WEST SUSSEX COUNTY COUNCIL CONSULTATION

TO:	Arun District Council FAO: Simon Davis
FROM:	WSCC - Highways Authority
DATE:	14 th July 2021
LOCATION:	Clays Farm North End Road Yapton BN18 0DT
SUBJECT:	Y/18/21/RES Approval of reserved matters following Y/62/18/OUT for 33 No. residential units, access, landscaping & associated works. This site is in CIL Zone 3 & is CIL Liable as new dwellings.
DATE OF SITE VISIT:	n/a (desk-top study)
RECOMMENDATION:	No objection
S106 CONTRIBUTION TOTAL:	n/a (see outline permission)

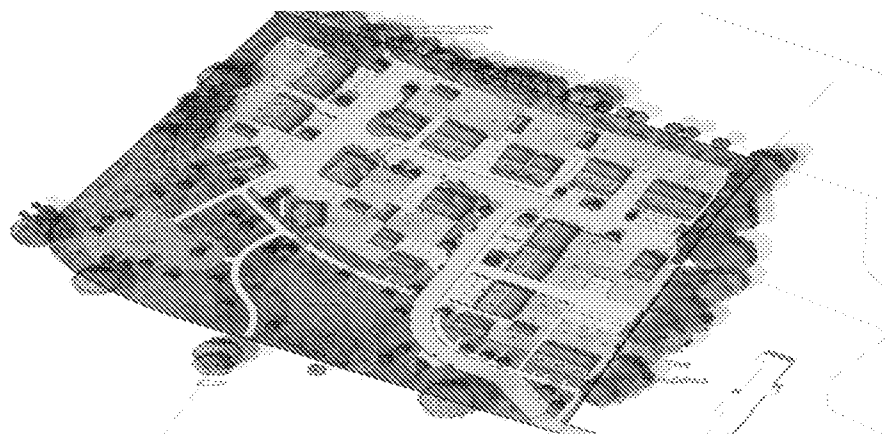
1. A detailed plan showing the section of access road from North End Road up to the start of the internal site layout. Please also provide the Road Safety Audit carried out for that section of road. This is required to show how it and the internal layout are proposed to work together. *A Safety Audit was carried out for the junction works with North End Road at the time of the outline planning application. Following this, a new plan has now been provided showing the access narrowed slightly at the point it joins North End Road to provide a short section of continuous footway running from North End Road into the first 15-20m of the site access to provide a separate footway for pedestrians before they have to walk in the shared-space area with vehicles. Additionally, swept-path diagrams for a refuse vehicle entering the access road coming-across a car leaving the development as shown on Drawing No. MBSK210702-01 Rev. P3 have been provided. While there is some overhang of part of the new footway caused by a refuse vehicle on entering from the north, this might only occur if the driver were faced with a vehicle leaving at the same time, otherwise they would have the full width of the access road to use upon entry. However, trips by refuse vehicles to the site would be very infrequent (likely once per-week) and drivers would themselves have an obligation to negotiate the junction carefully respecting other highway users including pedestrians which happens in many similar circumstances and scenarios elsewhere.*

The new layout plan (Drawing No. MBSK210702-02Rev. P1) has also been shown to the applicant's Road Safety Auditor (email from Martyn Parr of Mayer Brown to Alex Philpot, also of Mayer Brown Ltd., dated 13th July 2021) who considers that no material increase in risk to road users will arise as a result of the latest proposals.

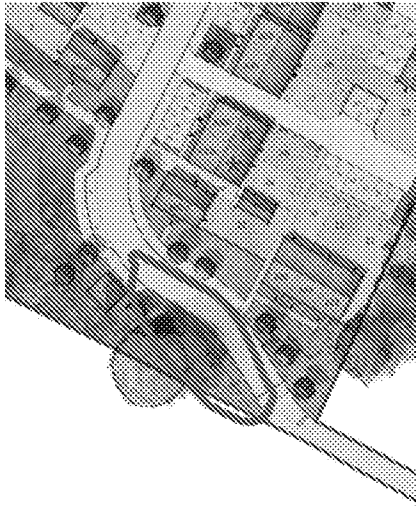
2. The internal road layout as currently shown would, in places, give a 'mixed-message' to users with regard to shared space and traditional footways and carriageway given lack of footways in one general area (north-western side of the main section of internal access road). It is recommended that a footway is provided on this side as well as the other – additional section as indicated on the extract below (see red dots):

The added advantage here is that pedestrians leaving the site on the southern side of the internal access road would be intervisible with drivers entering the site. Also, where this additional footway meets the entrance to the site opposite plot 33, it should be terminated here with a rumble strip provided just in advance of it (to the east). To correspond with this, the footway shown on the northern side outside of plots 31 to 33 should also be re-visited and possibly re-configured as where it is currently shown emerging to the access road pedestrians might be 'masked' from the view of drivers entering the development site by the adjacent land holding to the east. Visibility splays for pedestrians and drivers should also be added to the drawing. It may also be beneficial providing a form of speed restraint (or restraints) on the main access road leading into the site given that the space does not provide any separate footways. Internally to the site, pedestrian permeability is generally acceptable apart from the final section of footway which should be provided on the south-side of the access up to the point it meets the western-end of the initial access road from North End Road which has been shown as a grass verge whereas it should be a footway. This should be attended to at the build-stage. See below for affected area:
